## SEWAGE DISPOSAL SYSTEM HOWARD COUNTY HEALTH DEPARTMENT BUREAU OF ENVIRONMENTAL HEALTH 410-313-2640

UBDIVISION Forsythe Heights LOT NUMBER 3-B ADDRESS 14518 Monticello Drive

RE: **Building Permit Proposal**  
BP #: B00125575 (Proposed Pool)  
Forsythe Heights, Lot 3B  
14518 Monticello Drive

**SITE PLAN**  
SCALE: 1" = 50'

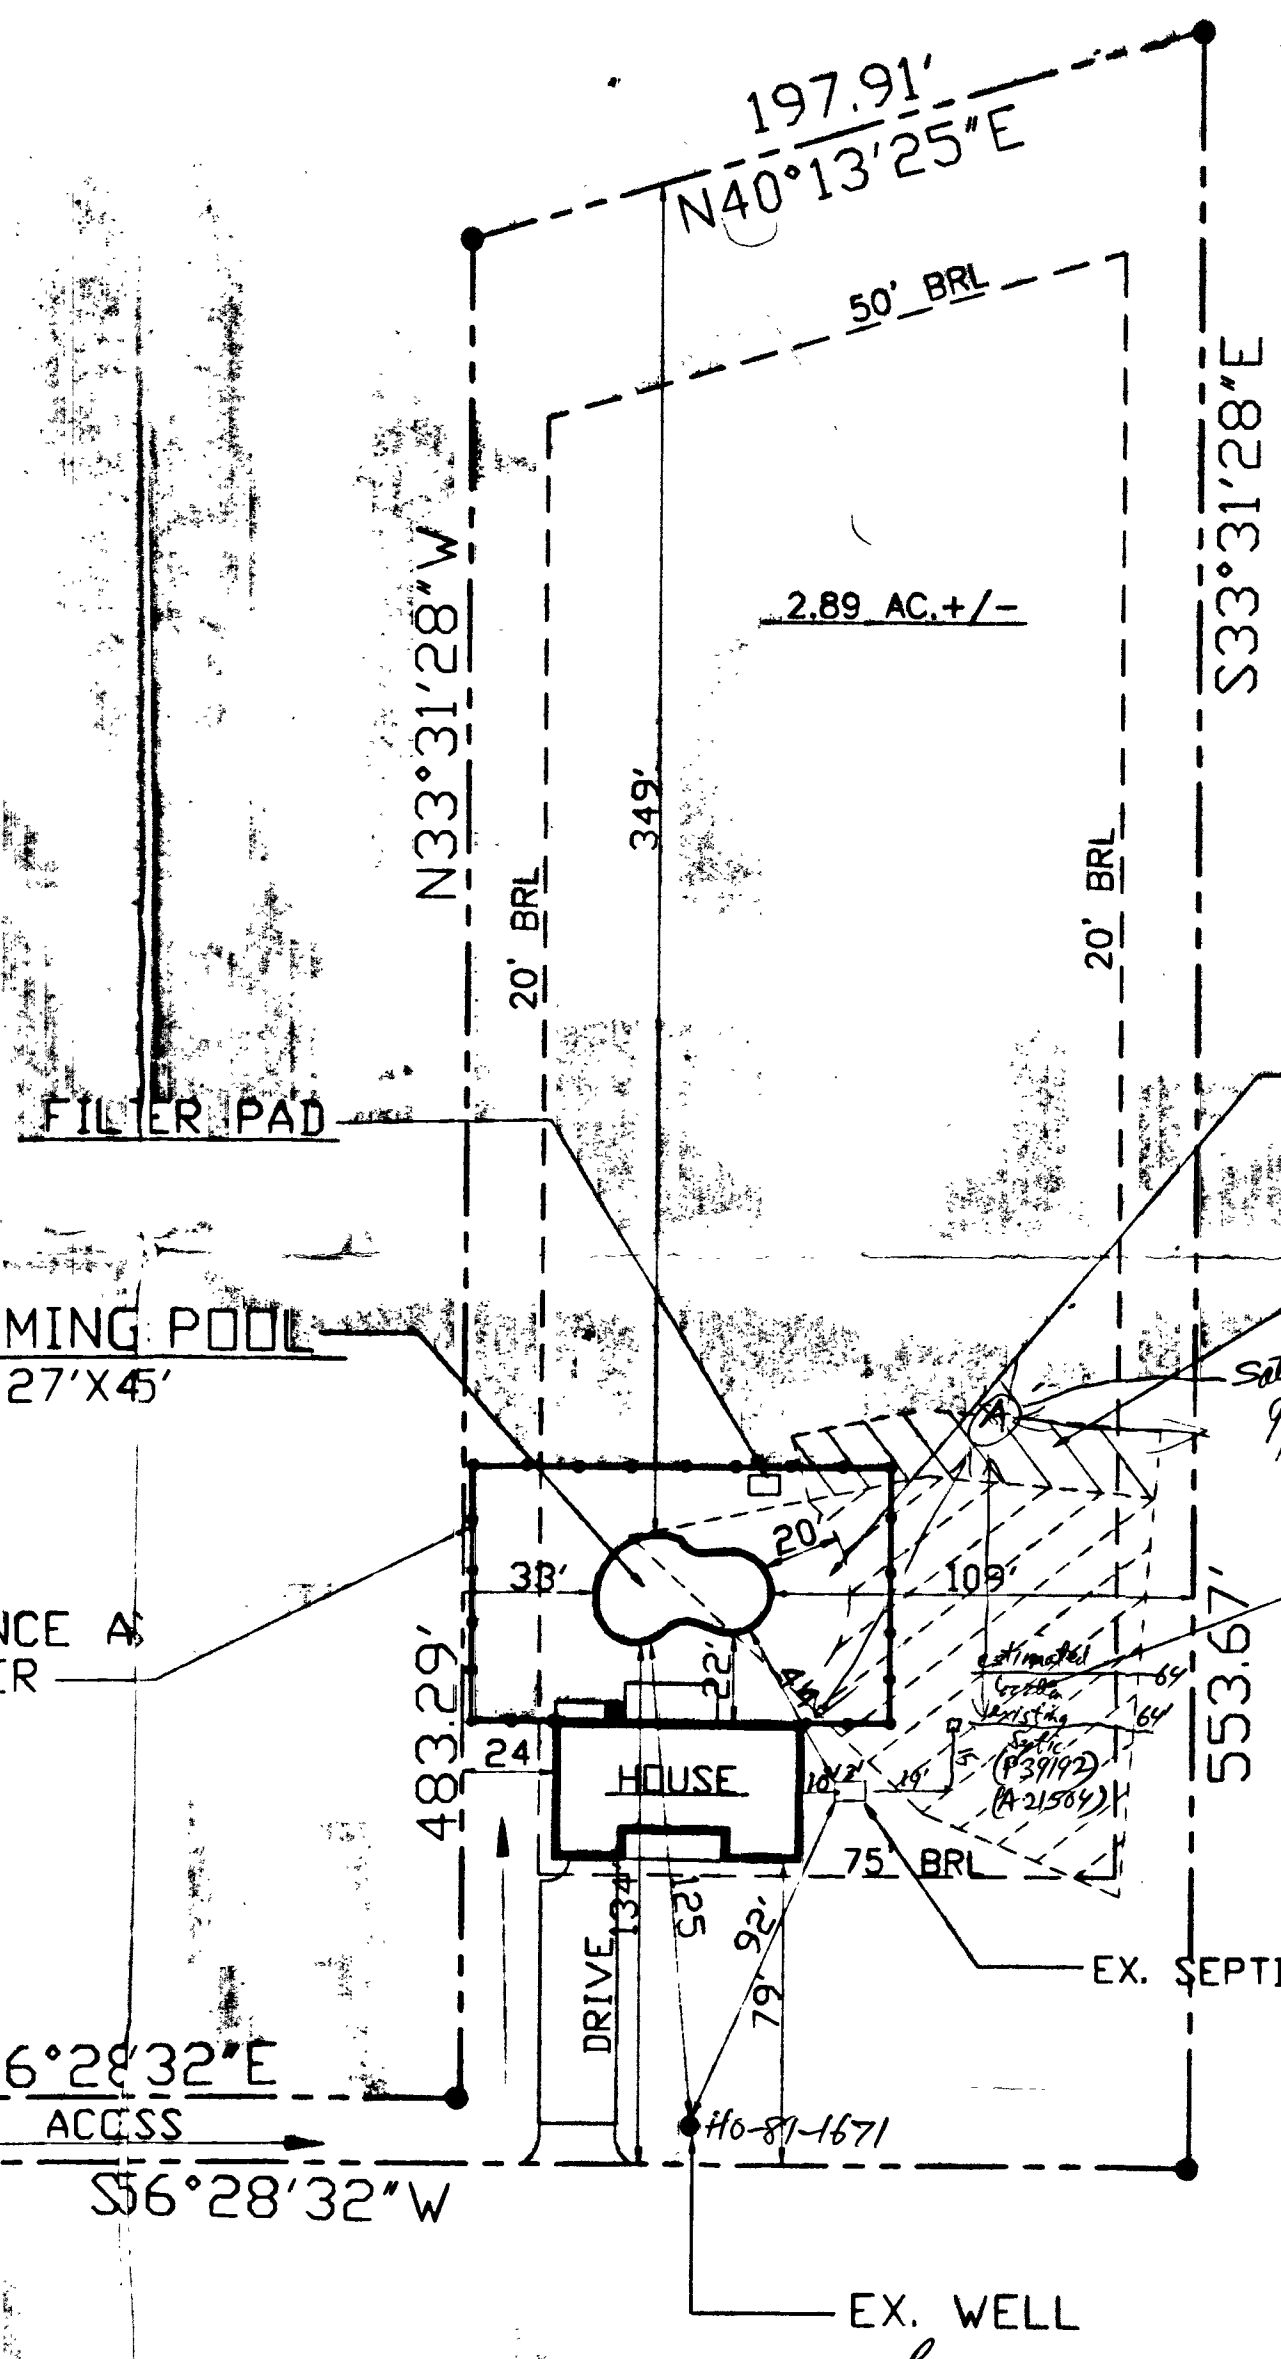
Our records indicate that the proposed location of the in-ground pool appears to compromise a portion of the platted sewage reserve disposal area established in 1975. This reserve area was created to establish an area of suitable soils for the installation for a future septic system repair when needed. A minimum of 20' separation to the proposed pool is required from the edge of this disposal area as well as the installed septic system trenches.

In conclusion, it is recommended that an alternative pool site is proposed. If you would like to proceed with the plan as presented, the existing sewage reserve area must be modified. To modify the sewage reserve area, additional perc testing must be performed so that an area of suitable soils may be established. Upon receipt of a completed application, a \$225 percolation test fee, and a suitable test plan, a tentative date will be scheduled. Checks can be made payable to the Director of finance. Please feel free to call me if you have any further questions.

B00125575  
OK to Release Building Permit  
for Swimming Pool (inspired)  
Objections to Release for Future Septic  
System 4/11/06

Revised system SDA is acceptable  
Approved Septic System Plan  
Howard County Health Department  
Signature: [Signature] Date: 7/20/06

LOCATION SURVEY  
 #14518 MONTICELLO DRIVE  
 4TH ELECTION DISTRICT  
 HOWARD COUNTY, MD.  
 DEED: 1591 - 198

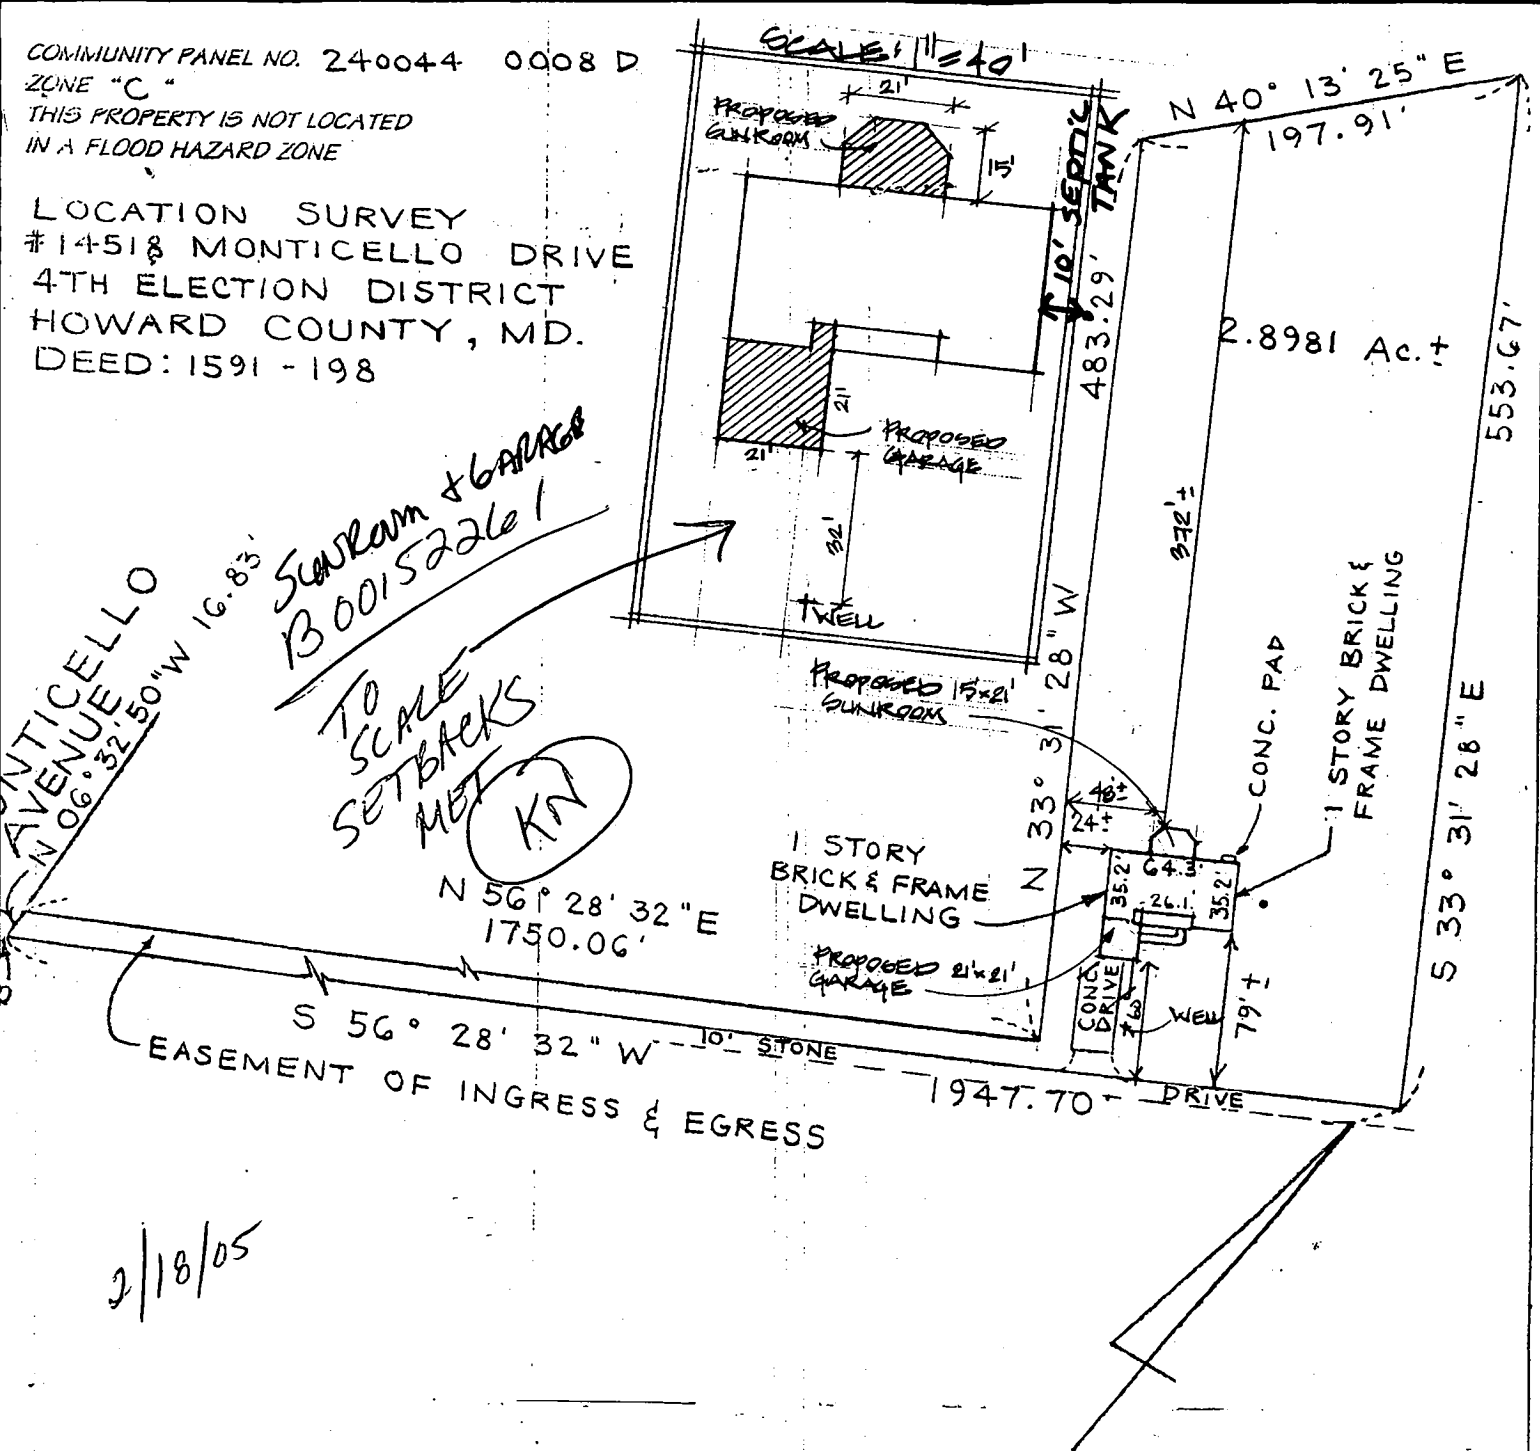
*Handwritten:* SWORAM & GARAGE  
 1300152261  
 TO SCALE  
 SETBACKS  
 MET  
 KN
